June 18, 2024

Current Spacing for 3/4" Anchor Rods

New Revised Spacing — 3/4" & 1" Anchor Rods

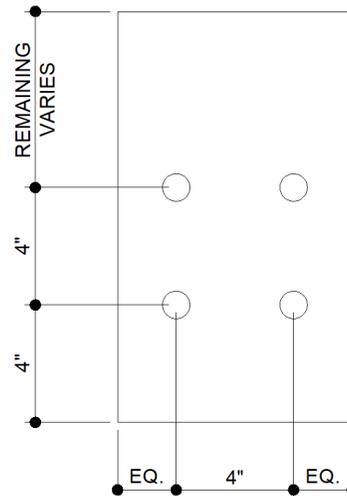
In an effort to align anchor rod spacing for 3/4" and 1" diameters, the standard spacing for 3/4" rods has been revised as shown below. This revised spacing will aid in eliminating confusion when setting rods to accommodate both diameters. In addition, the revised 3/4" rod spacing will eliminate tightening issues that are being experienced due to weld bead interferences.

Critical Dates: This change was introduced in our Design and Detailing software June 14, 2024. All jobs processed with the newer software after this date will include the revised spacing.
